Re: 181 Jerome Place  
Map 13 Block 307 Lot 19  
Pablo Baiza Castro (applicant/owner)  
Zone: R-1B, Single Family Residence District

This application requests variance relief for resurfacing the existing driveway, constructing a paver walkway, and extending the paver patio area.

Attachment #1:

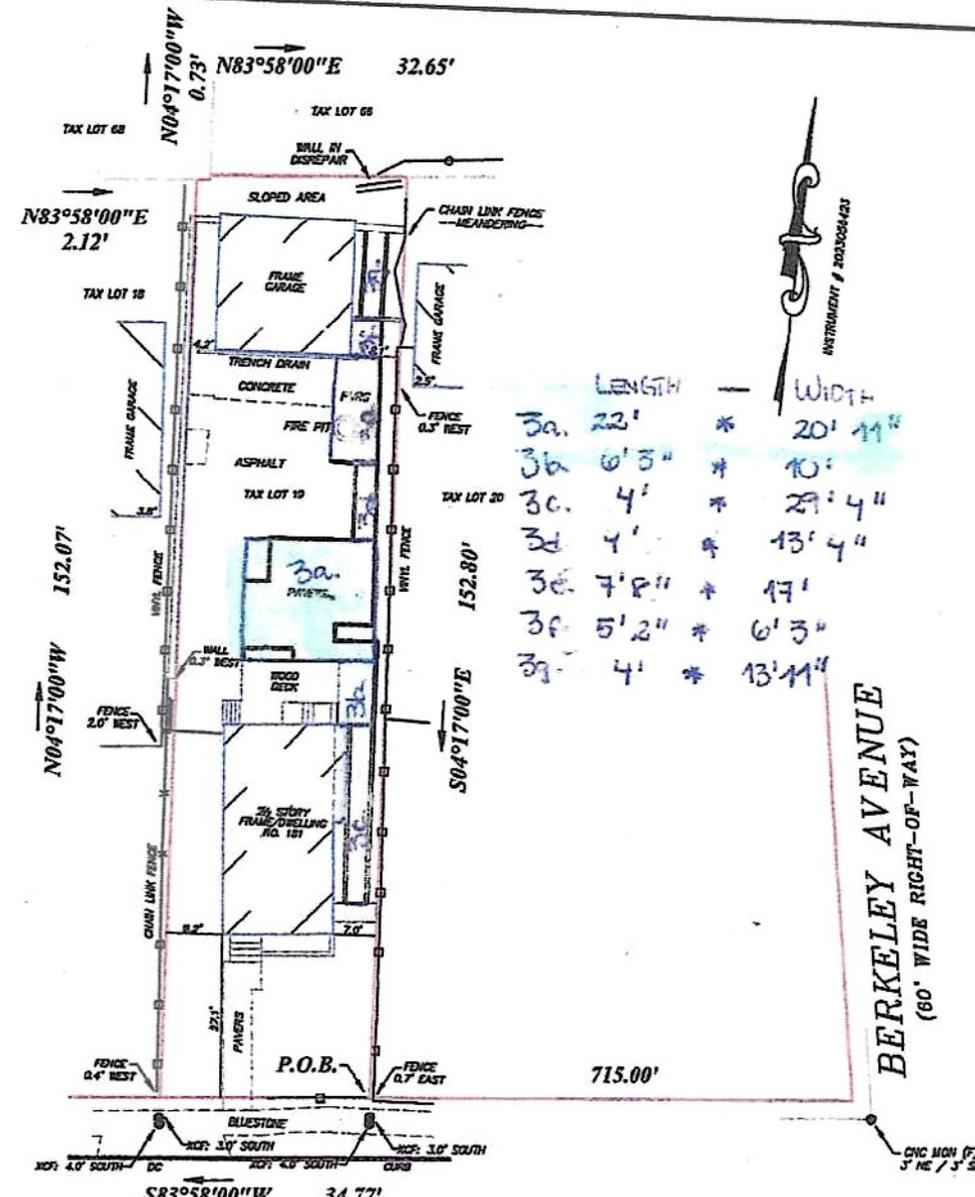
This is the marked-up copy of the property survey provided by the applicant.

Board members will note that this marked up copy of the property survey is reduced in size and therefore is not to scale.

Apparently, the applicant has constructed a paver patio in the rear of the property which also extends into the side yard along the east side of the dwelling, and along the east side of the detached garage.

Attachment #2:

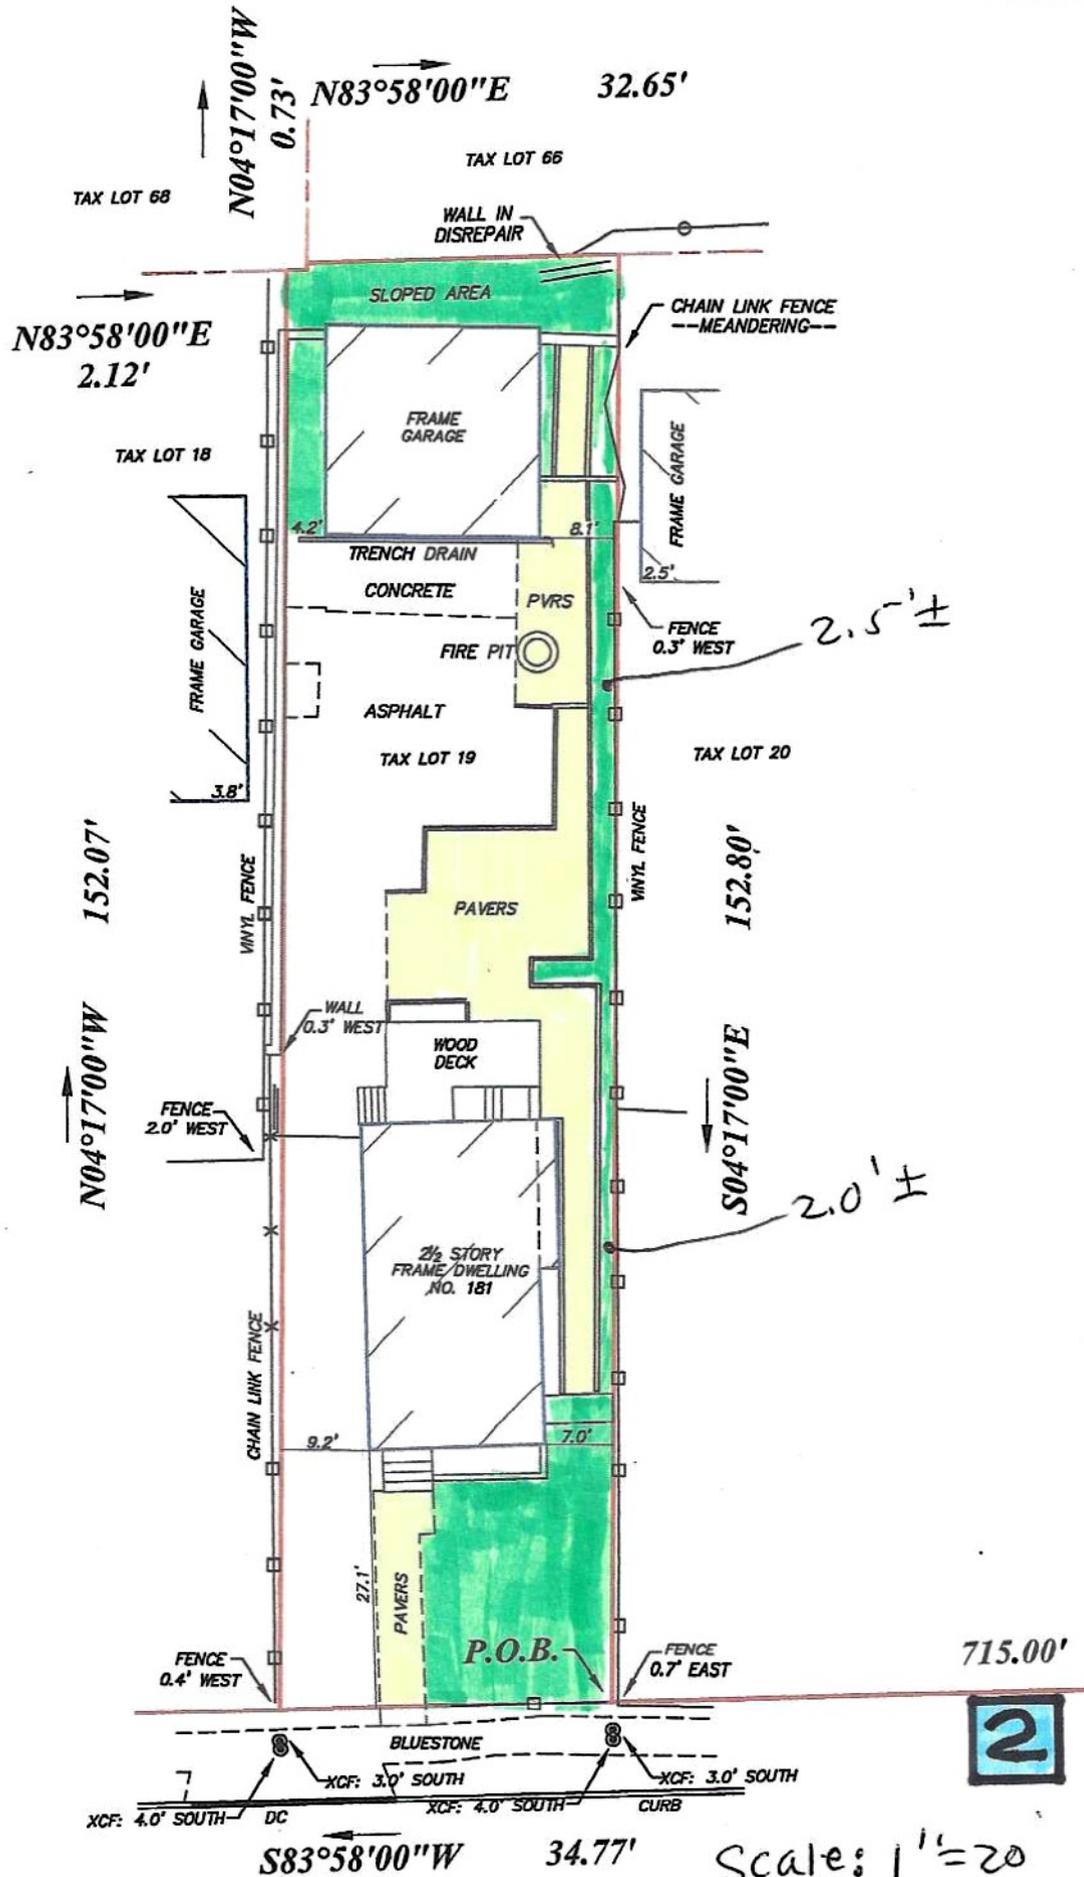
This is scaled copy of the property survey, highlighted by my office, indicating the extent of impervious coverage by all existing structures and pavements on the subject property.

It appears that approximately 89% of the subject property consists of impervious materials.

- Schedule A: Bulk & Setback Regulations.  
The constructed paver patio and walkways exceed the maximum permitted lot coverage.  
Existing Lot Coverage = 89%  
Maximum Permitted Lot Coverage = 60%
- Section 315-36(D)94): All decks, patios and terraces shall be located in the rear yard only, and must meet the required yard setbacks for principal buildings.  
Portions of the patio are located in the side yard.  
Existing Side yard Setback = 2.0 to 2.5 feet.  
Minimum Required Side Yard Setback = 6 feet.
- Testimony shall be provided by the applicant with respect to the required Class C Bulk & Setback variance relief.
- It should be noted that the subject property is located just outside of a FEMA regulated Flood Hazard Area, due to its proximity to the Second River, as shown on Attachment #3.

# National Flood Hazard Layer FIRMette

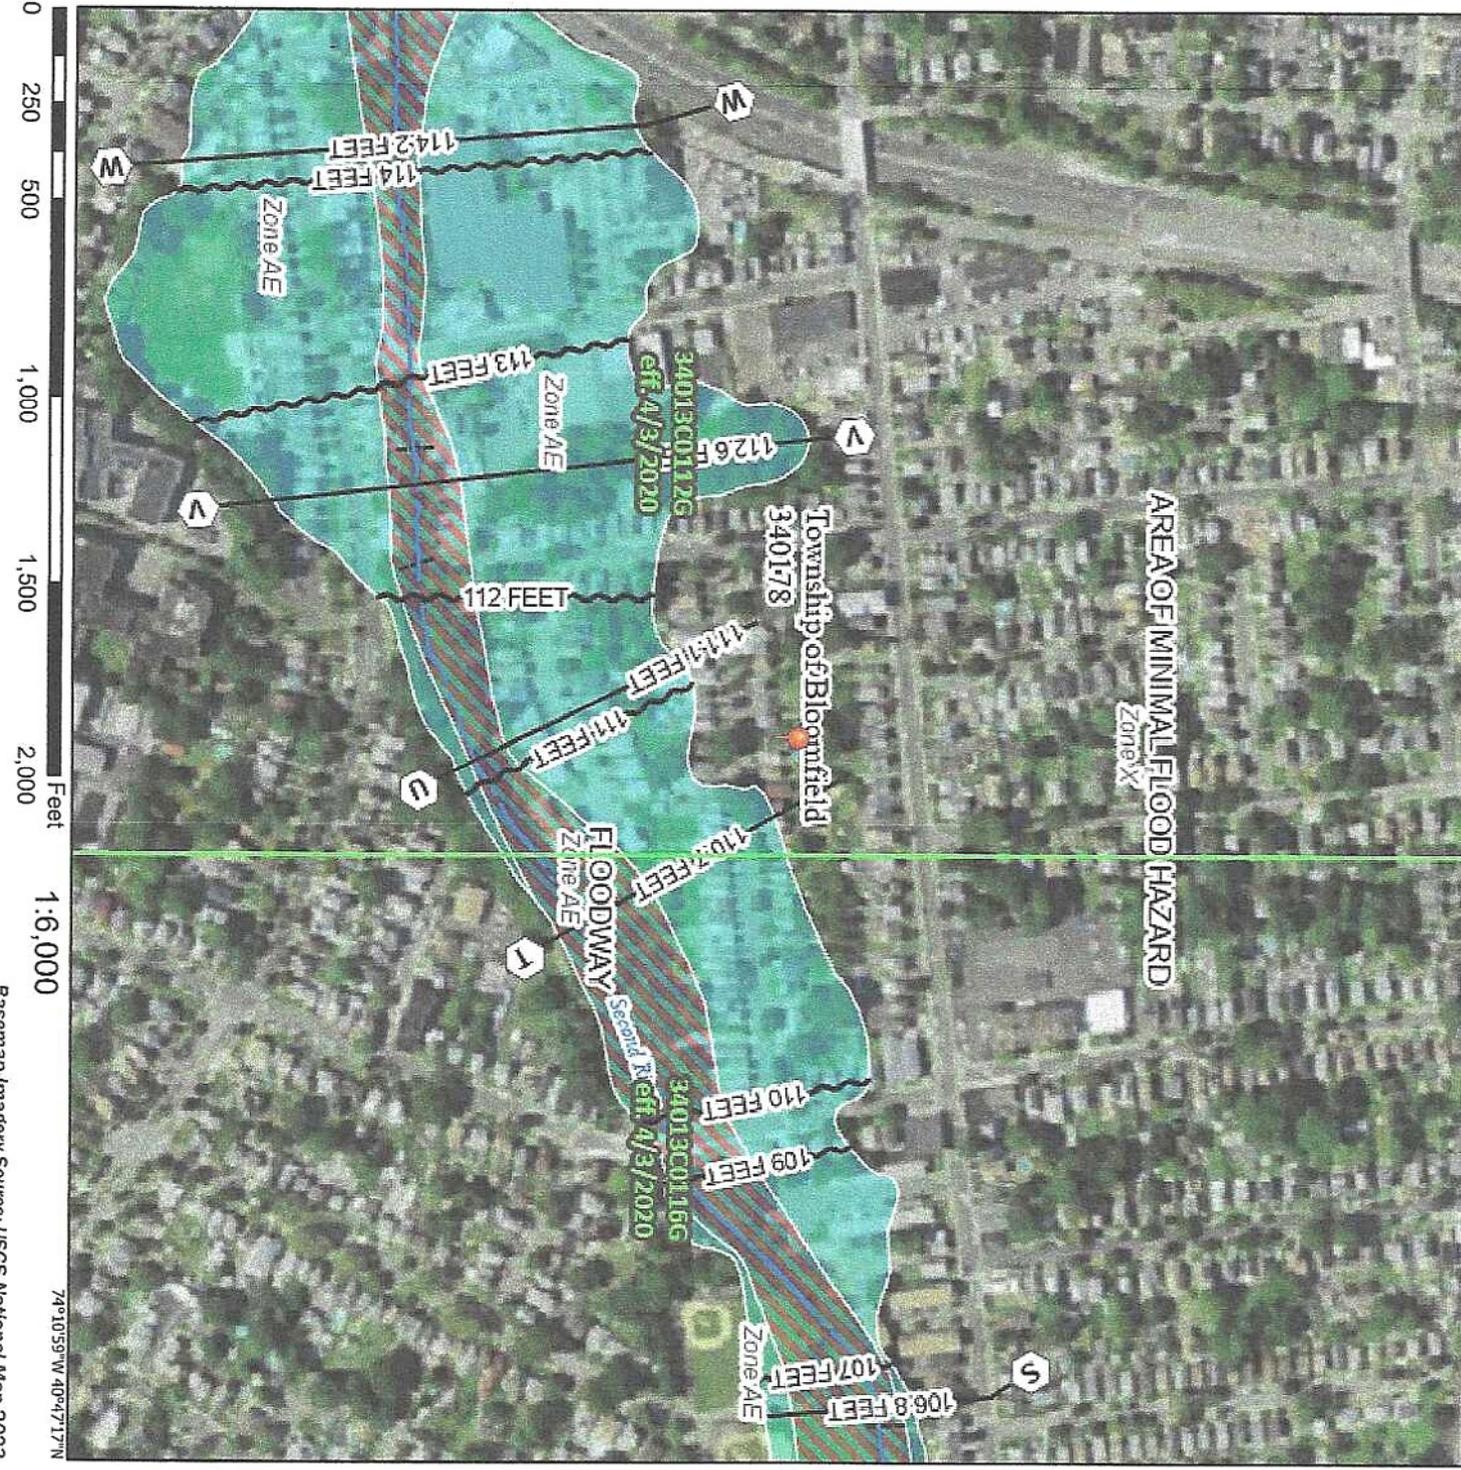
Any increase in impervious coverage on the subject property may, potentially, adversely affect downstream properties.
